Theater Missile Defense Extended Test Range

Final
Environmental Impact Statement

November 1994

Volume I begins with the Executive Summary and Acronyms and Abbreviations. Section 1.0 of the Final EIS contains the introduction. Section 2.0 contains the additions and revisions to the Draft EIS and to the Supplement to the Draft EIS. Section 3.0 contains the responses to comments that were made on the two documents, and Section 4.0 includes an index to the commenters. Section 5.0 contains the agency comment letters and responses that pertain to the Draft EIS and the Supplement to the Draft EIS, while Section 6.0 lists the references used in the preparation of the Final EIS. Section 7.0 contains the list of preparers of the EIS, and Section 8.0 contains the distribution list for the document. Section 9.0 contains copies of the transcripts, exhibits, and written comments pertaining to the Draft EIS relevant to the Western Range Candidate Test Area. Section 10.0 contains copies of the transcripts, exhibits, and written comments pertaining to the Draft EIS relevant to the Eglin Air Force Base Candidate Test Area. Appendix A contains a discussion of cumulative impacts for the EIS, and Ap

Figure 2.2-32

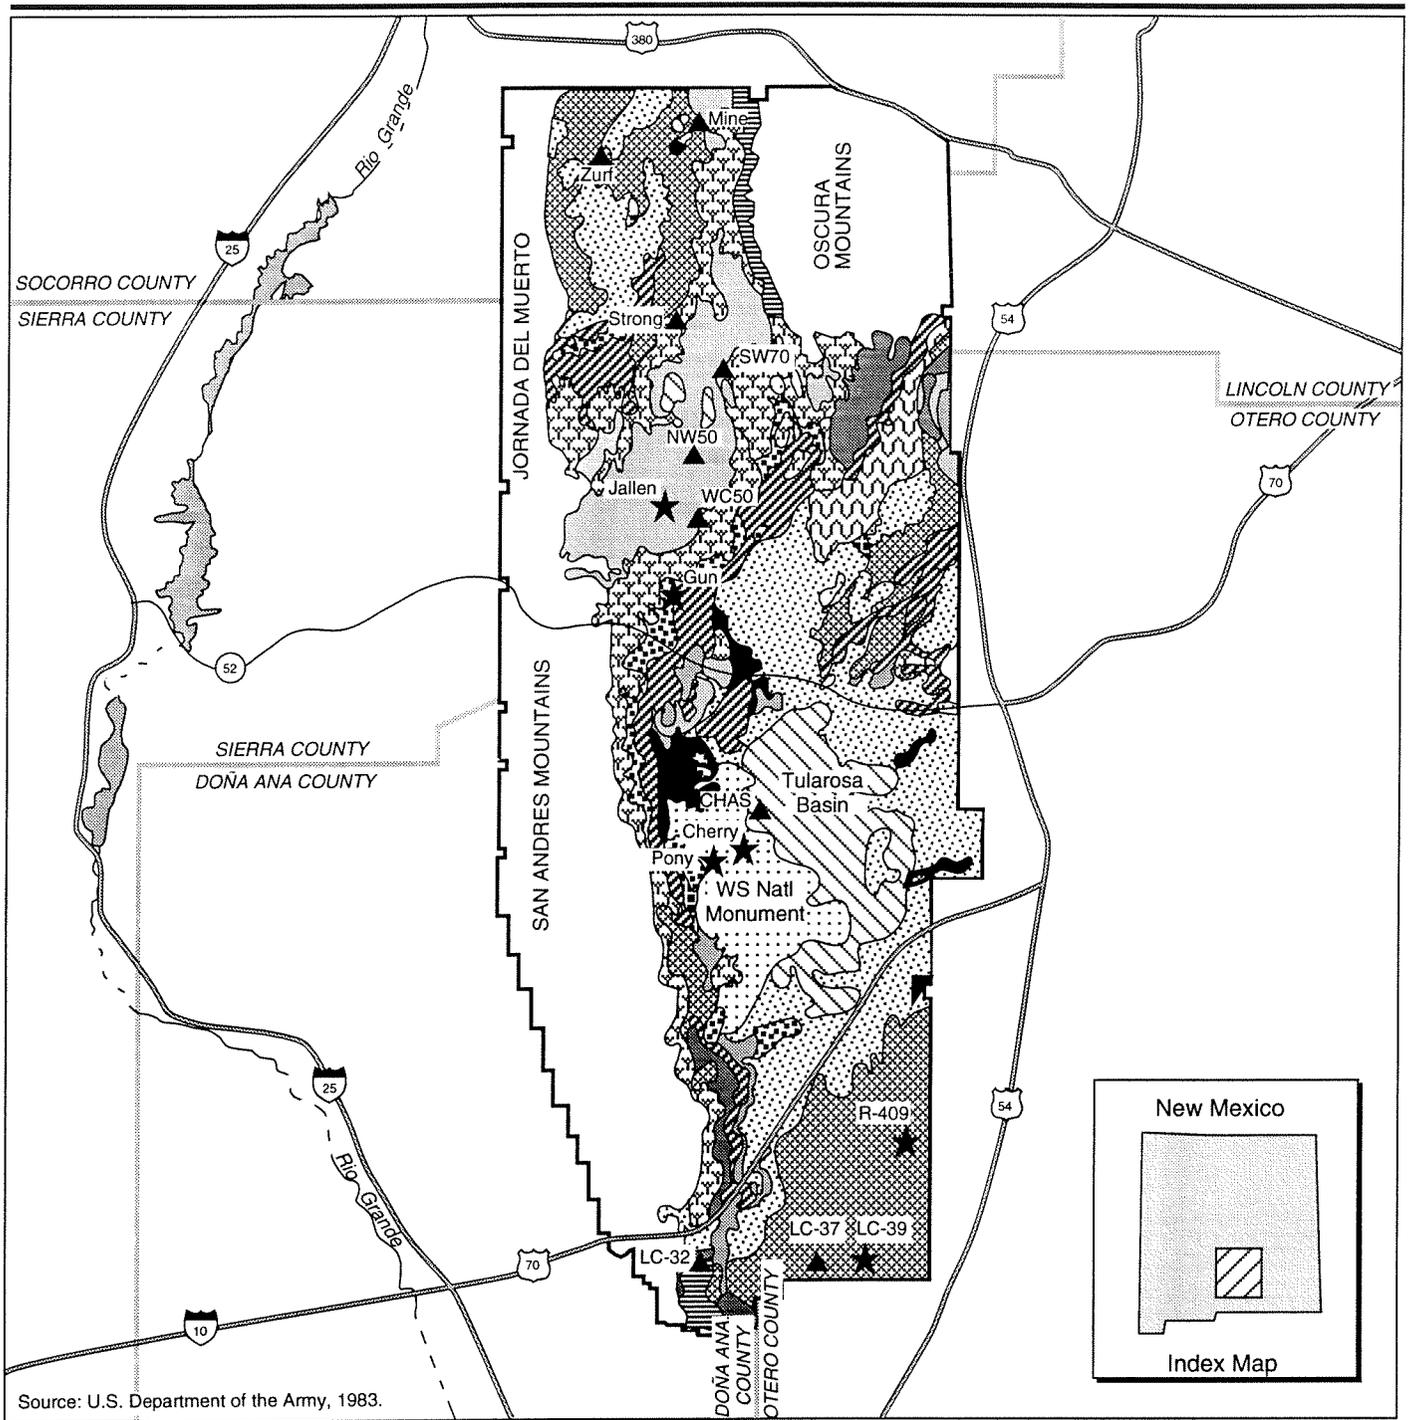
Page 2-85, figure 2.2-32: Figure has been revised as shown.

Figure 3.1-2

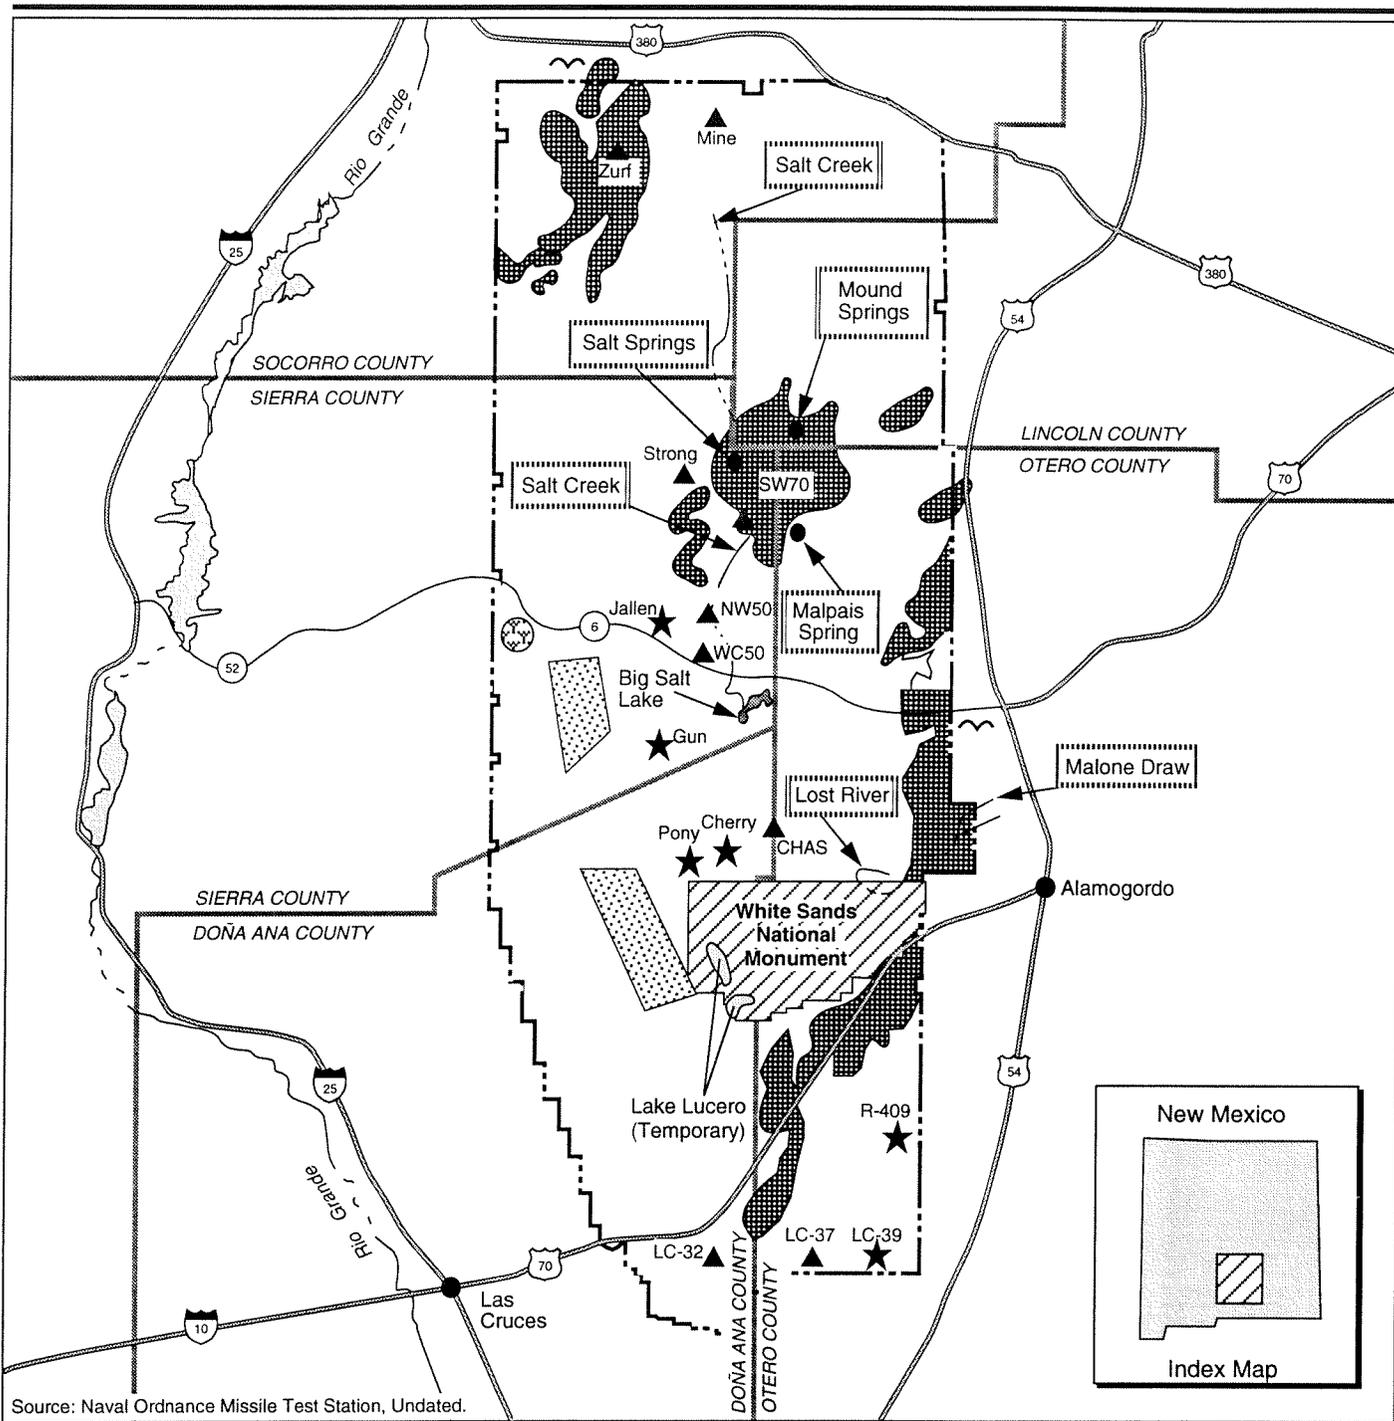
Page 3-19, figure 3.1-2: Figure has been revised as shown.

Figure 3.1-3

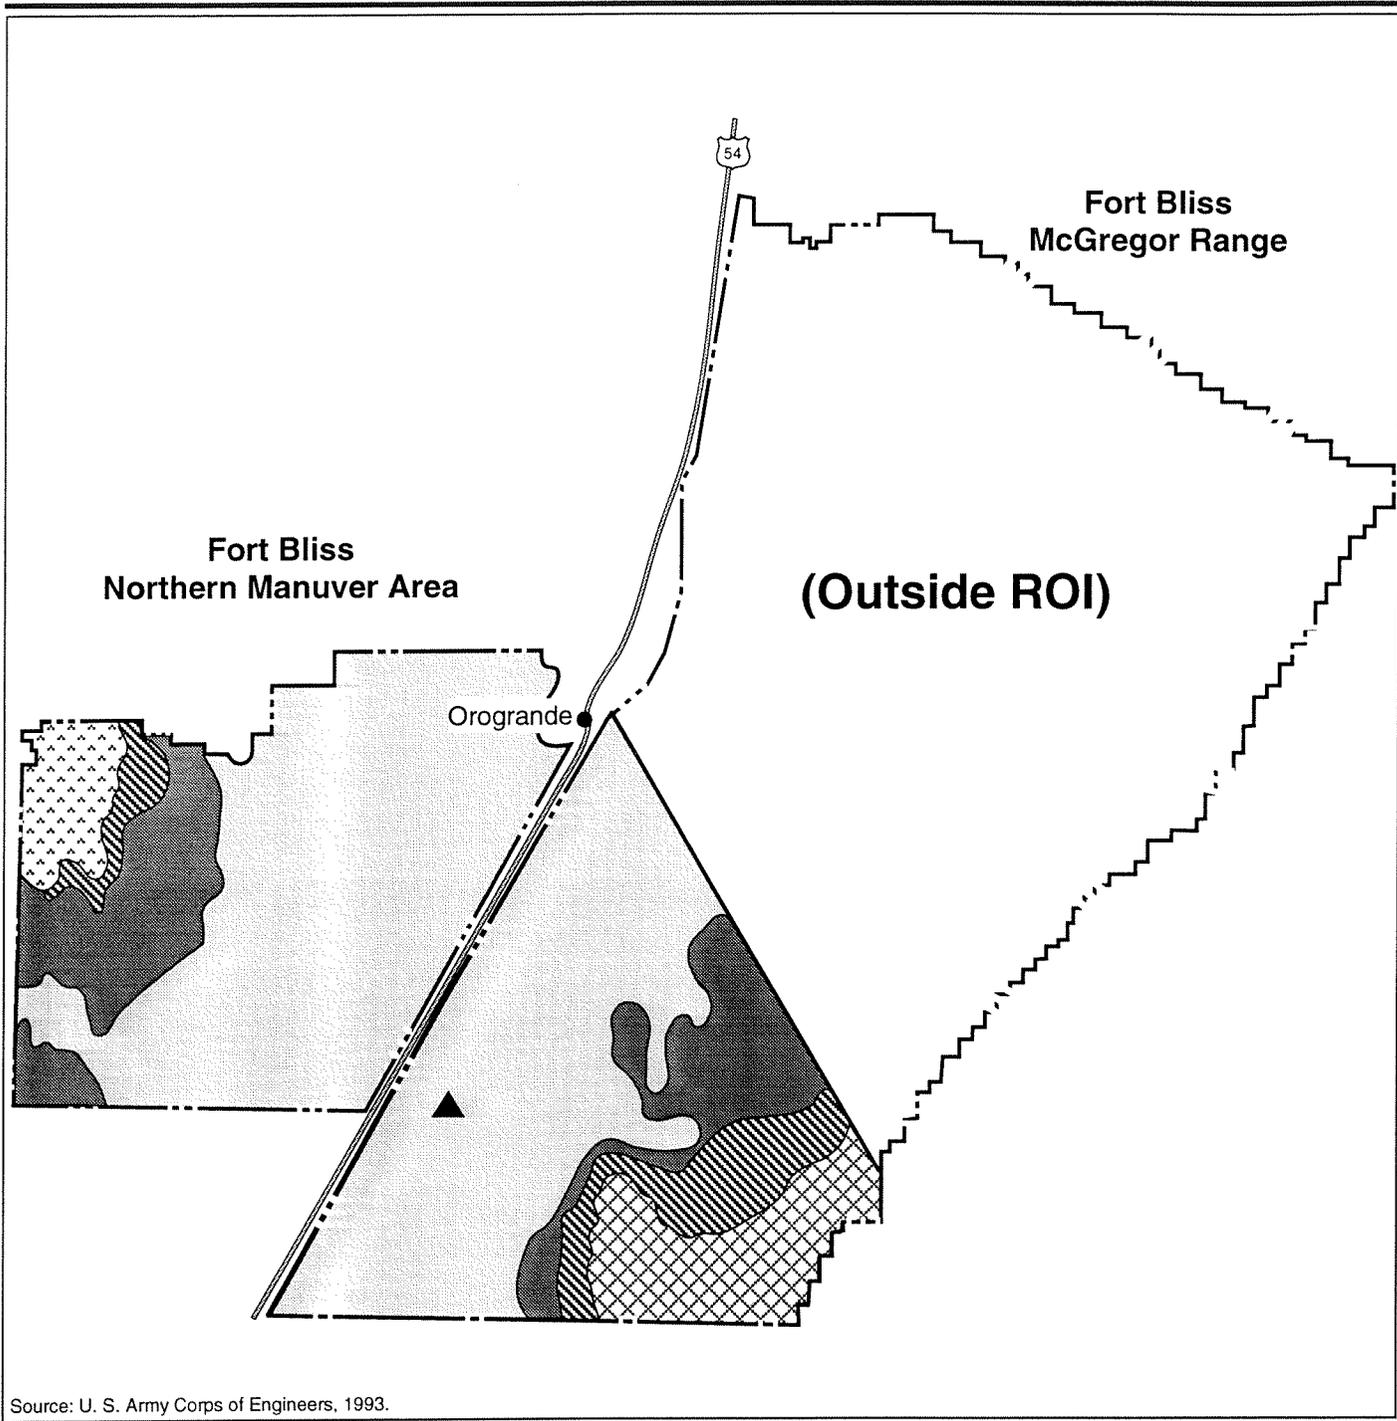
Page 3-20, figure 3.1-3: Figure has been revised as shown.

Figure 3.1-4

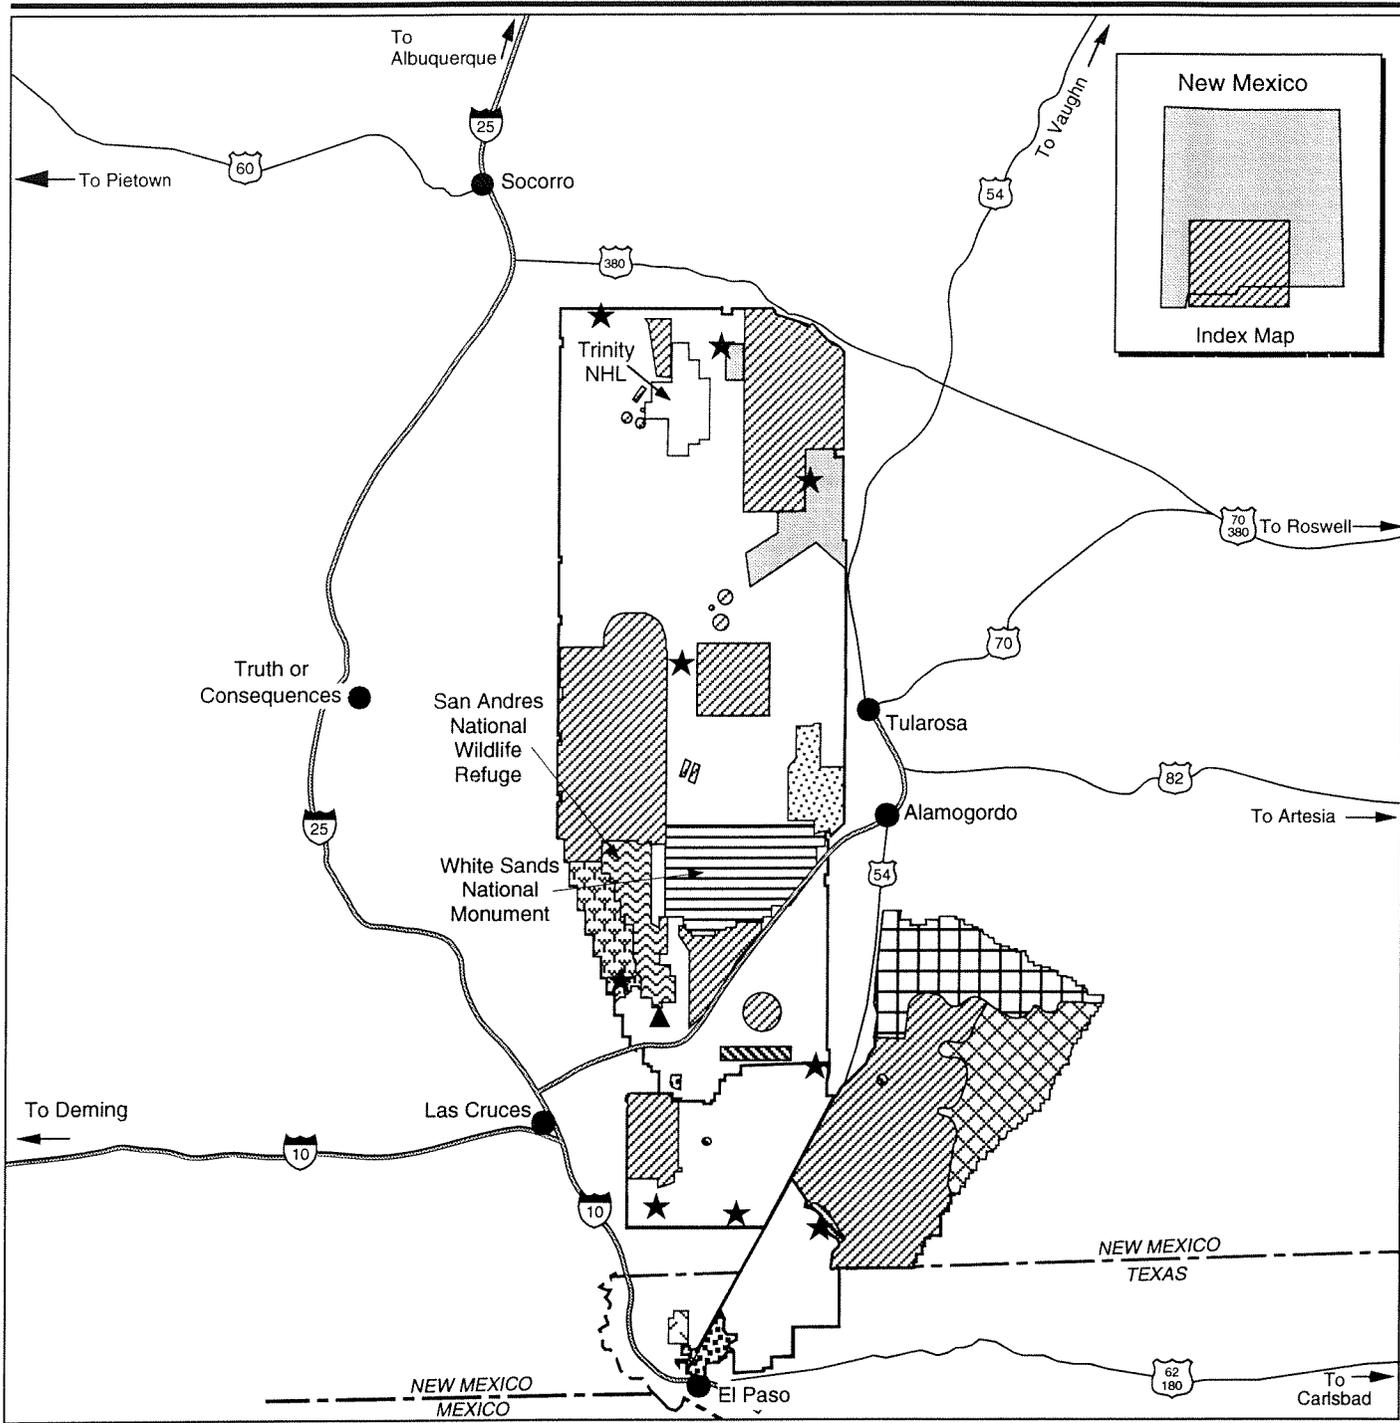
Page 3-22, figure 3.1-4: Figure has been revised as shown.

Response: Figure 3.1-4 has been altered to reflect the area of Fort Bliss McGregor Range which would be used in the TMD program. Only the southern portion of McGregor Range and the Fort Bliss Maneuver Area would be used.

Figure 3.1-6

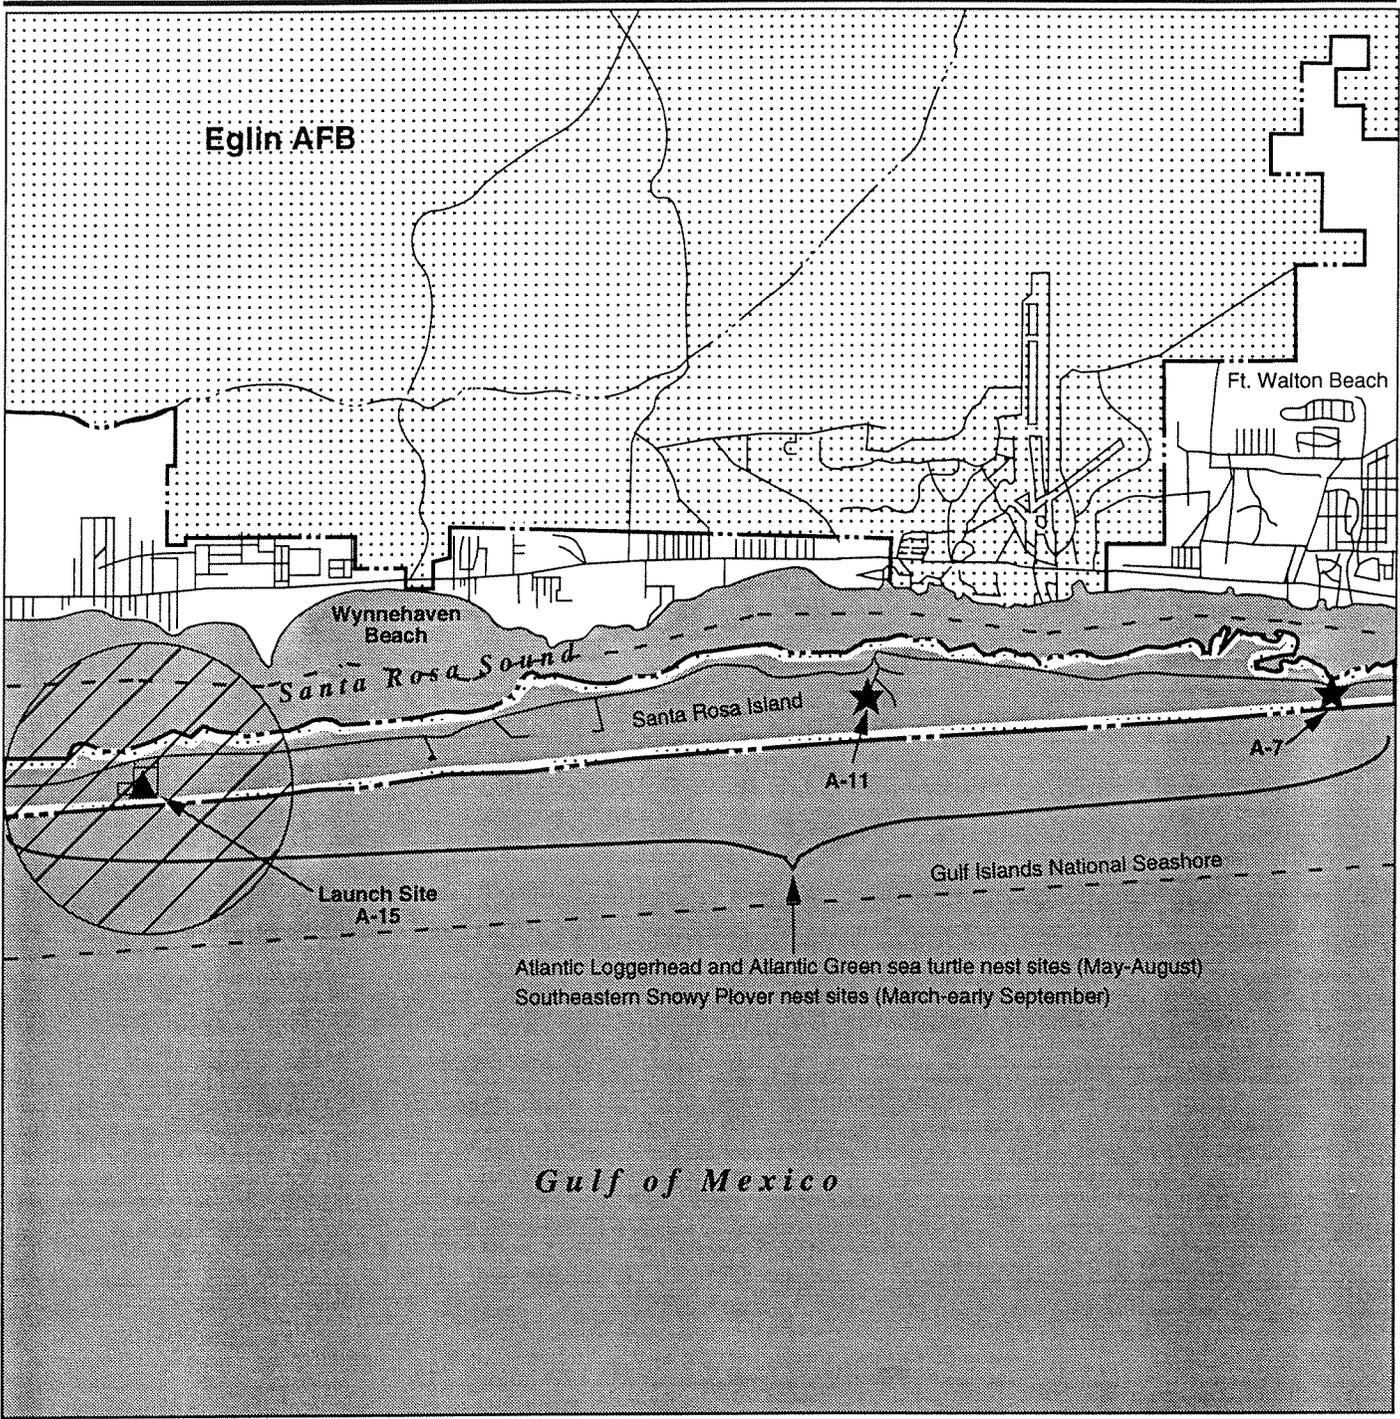
Page 3-39, figure 3.1-6: Figure has been revised as shown.
